**CITY OF VAUGHAN**

**EXTRACT FROM COUNCIL MEETING MINUTES OF DECEMBER 13, 2016**

**32 ZONING BY-LAW AMENDMENT FILE Z.16.003  
SITE DEVELOPMENT FILE DA.16.007  
SITE DEVELOPMENT FILE DA.16.089  
PENGUIN-CALLOWAY (VAUGHAN) INC.  
WARD 4 - VICINITY OF MILLWAY AVENUE AND APPLE MILL ROAD**

## Revised Site Plan (File DA.16.007)

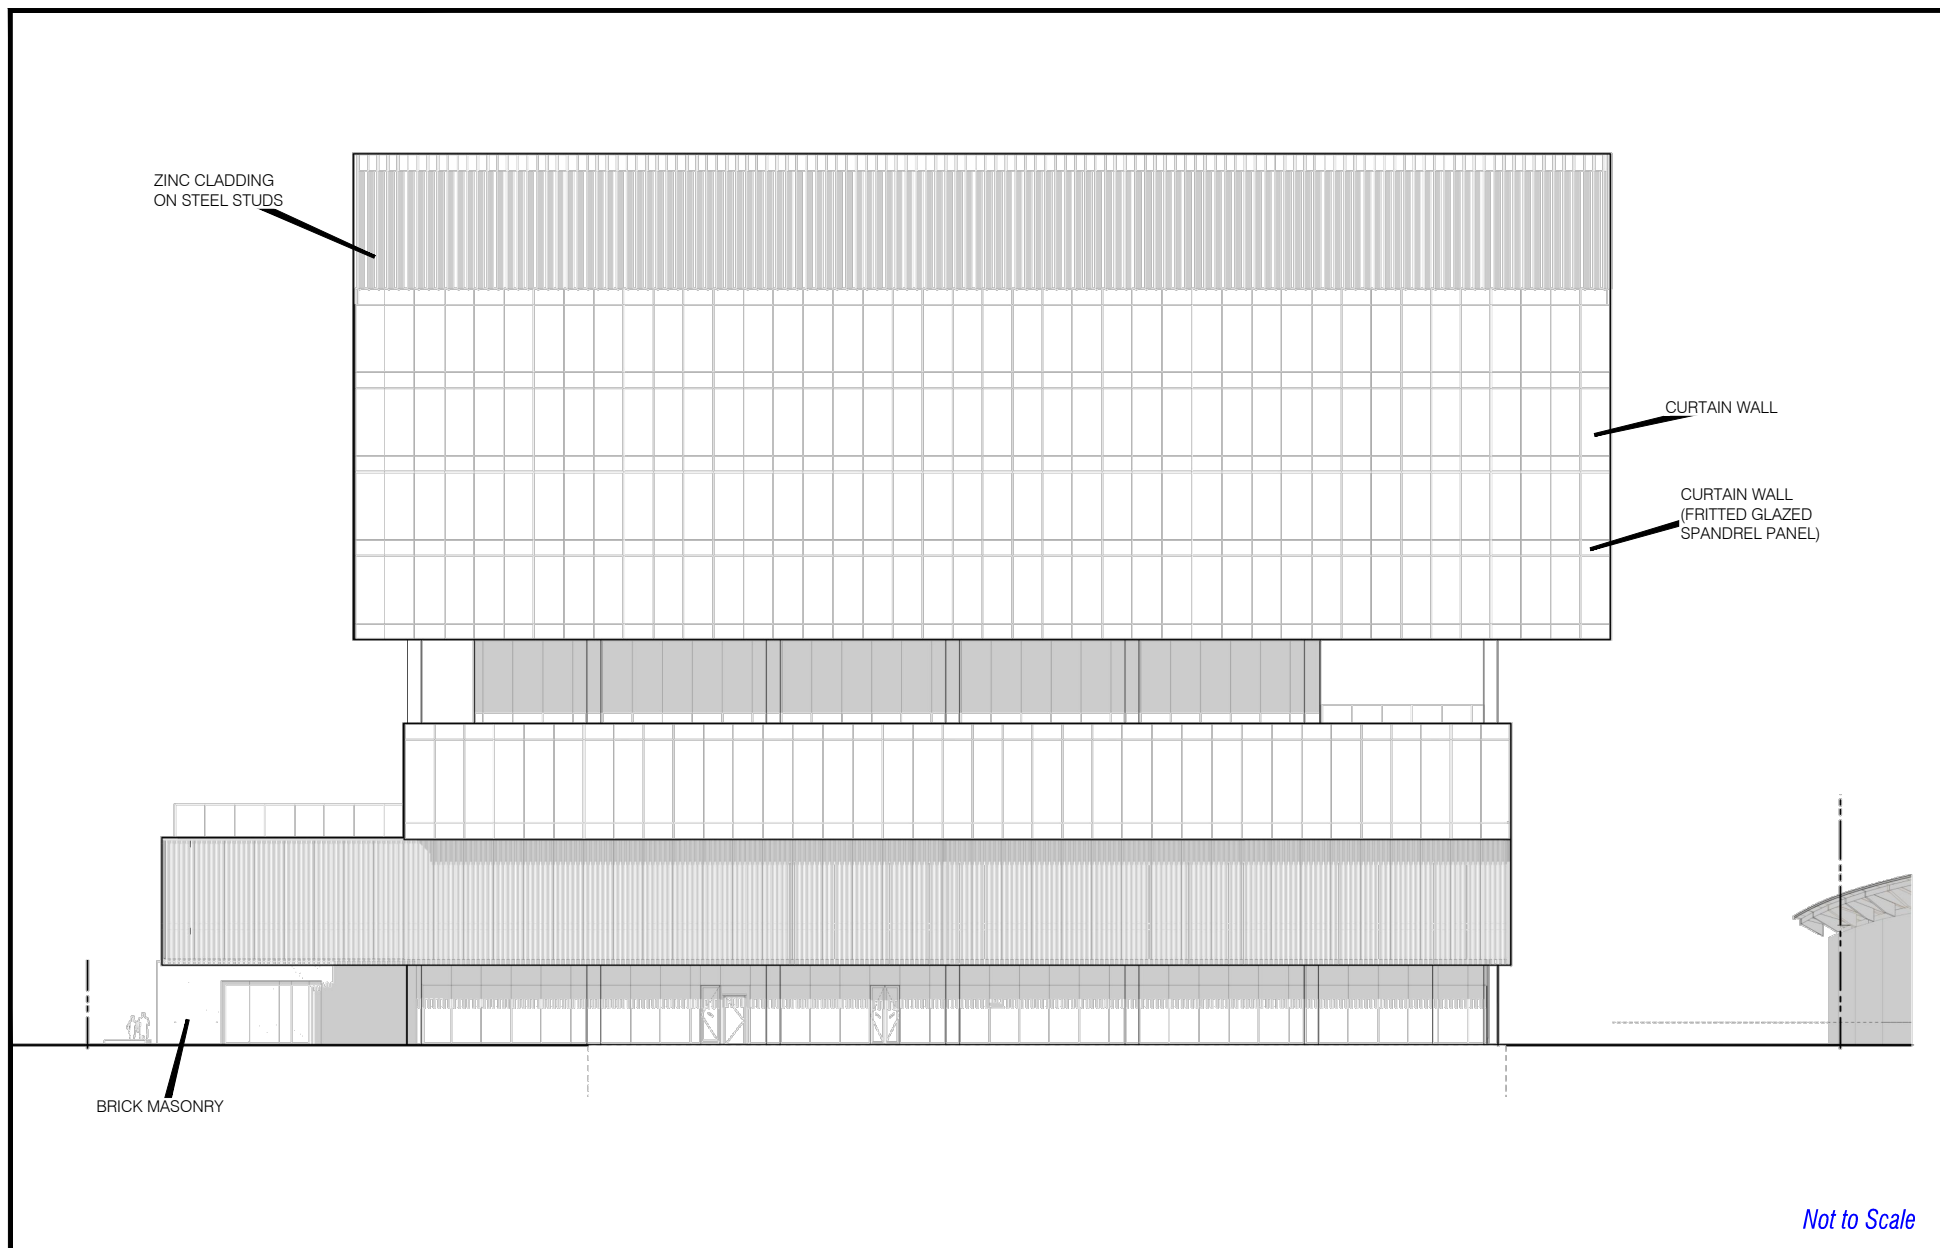
An outdoor play area associated with the day care use is located on the west side of the building. A private driveway identified as “Future Buttermill Avenue Extension” on Attachment #6 is located along the west side of the building, extending north from Apple Mill Road. Upon the redevelopment of the Wal-Mart site to the west, this driveway will form part of Buttermill Avenue, a planned 22 m wide public right-of-way that will connect Apple Mill Road to Portage Parkway. The mixed-use building is proposed to be serviced along the north side of the building, which will be animated with second floor active uses.

The Owner responded to the DRP's comments with the revised proposal shown on Attachments #6 to #12. The revised development proposal incorporates colour and fritted glass treatment at the podium level, specifically the podium will be activated with visible uses (community centre gym) along the north of the building. The main entrances have designed with more prominence

## Red-Lined Site Plan (DA.16.089)

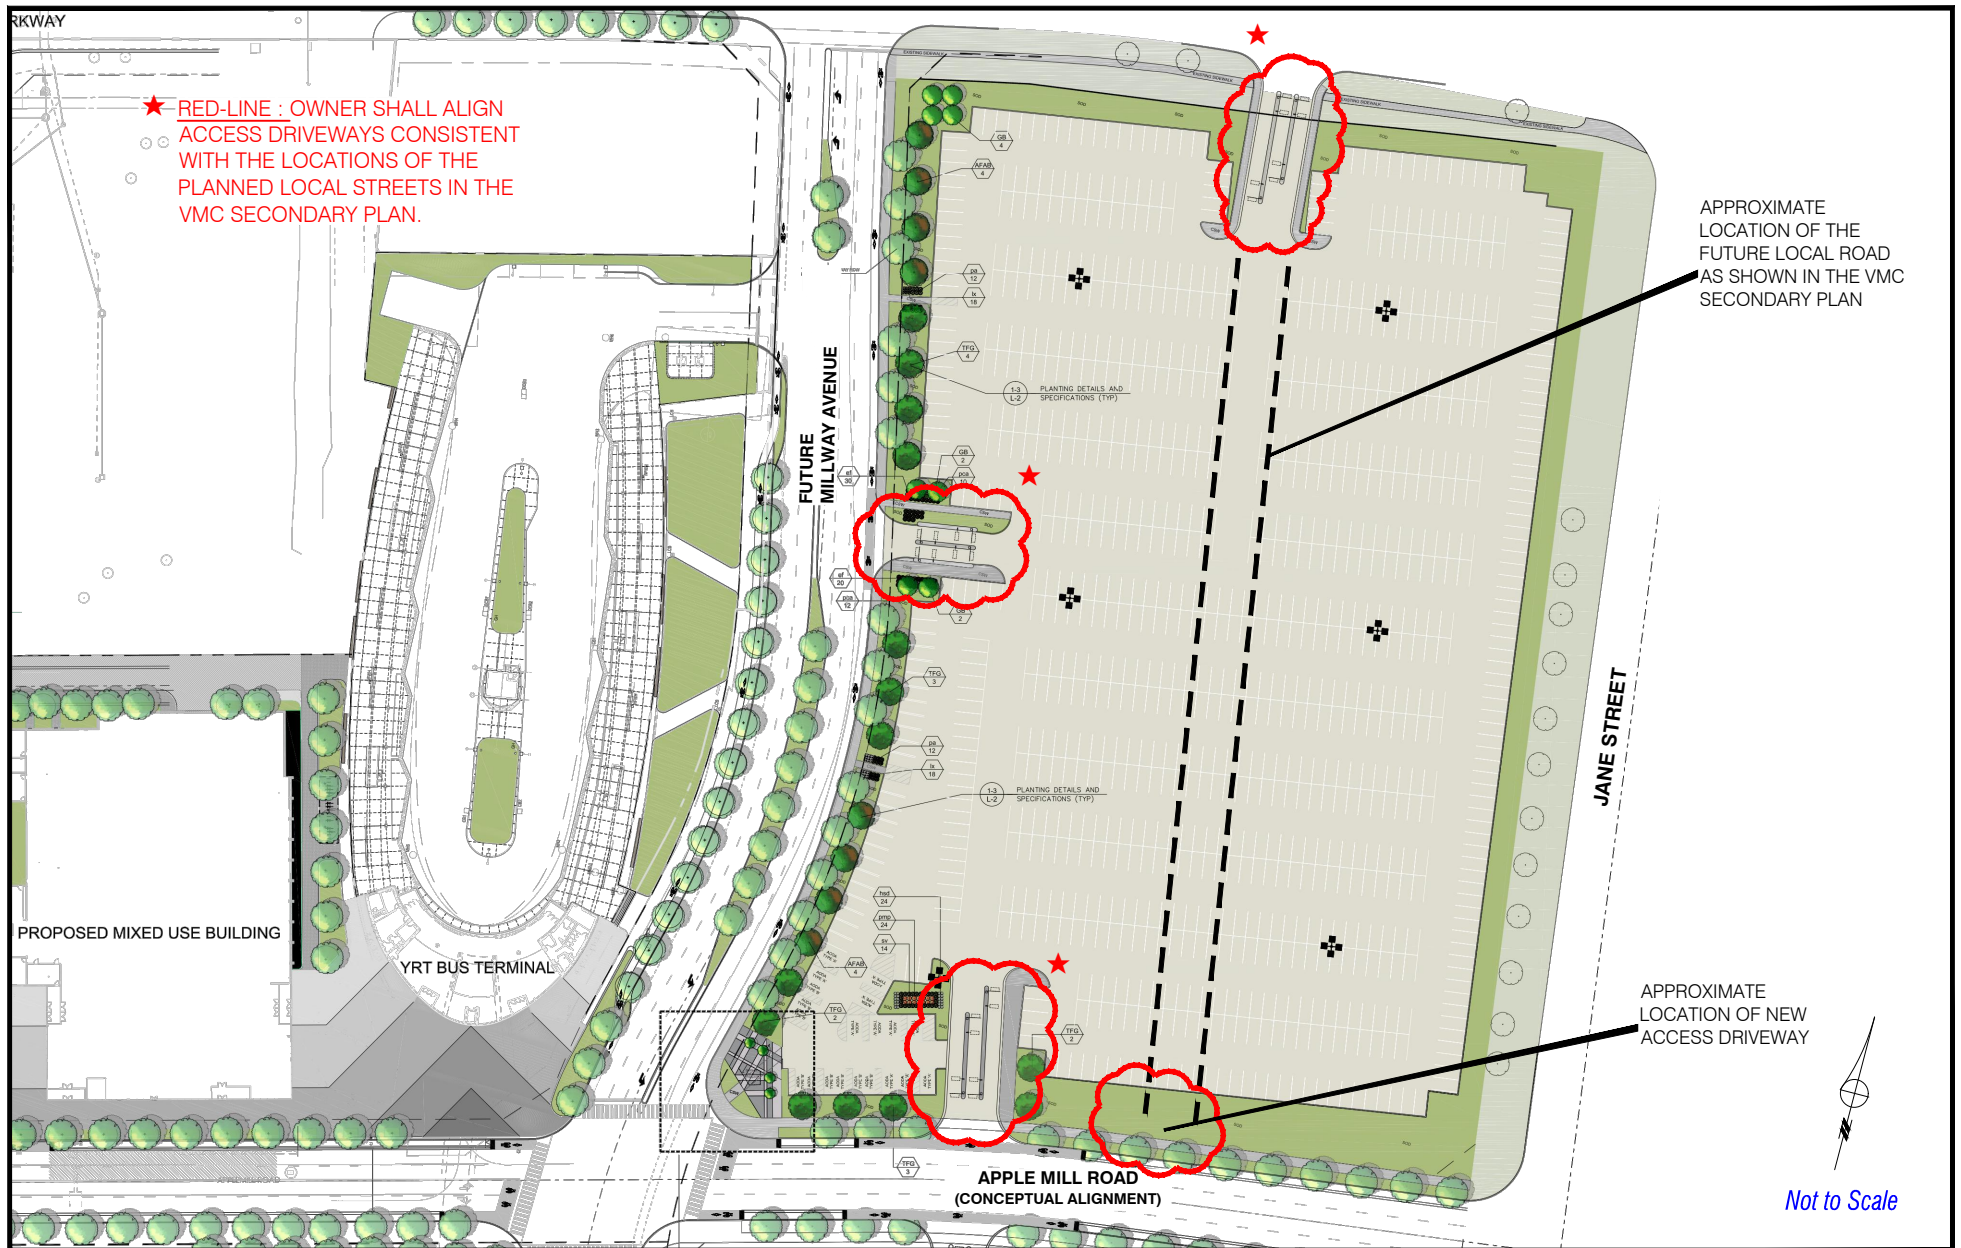
The Vaughan Development Planning Department recommends the approval of a temporary surface commercial parking lot consisting of 976 parking spaces, as red-lined on Attachments #13 and #14, subject to the Owner entering into an agreement with the City, which will include the following triggers for the ultimate removal of the parking lot the following conditions:

Access driveways to the temporary surface commercial parking lot are proposed on the Apple Mill Road extension (full move access) and Millway Avenue and Portage Parkway (right-in and right-out). The Owner has agreed to align the access driveways for the temporary surface commercial parking lot to be consistent with the general location of a planned local street shown in the VMC Secondary Plan. The temporary proposed parking lot site plan shown on Attachments #13 and #14 has been red-lined to reflect this change. Each access driveway is currently proposed to be gated and controlled, but this may be reconsidered to avoid negative traffic impacts.

A sidewalk on the north side of Apple Mill Road will serve as the main pedestrian route connecting the temporary parking lot to the mixed-use building, as shown on Attachment #13, and the YRRTC Bus Terminal. Sidewalks on Millway Avenue extending south from Apple Mill Road will connect to the VMC Subway Station entrance. The distance from the temporary surface commercial parking lot to the mixed-use building is within 400 m or less than a 5 minute walk. The Owner will be required to coordinate wayfinding signage to the City’s standards and in response to the comments from the Toronto Transit Commission (TTC) and York Region, which is discussed later in this report.
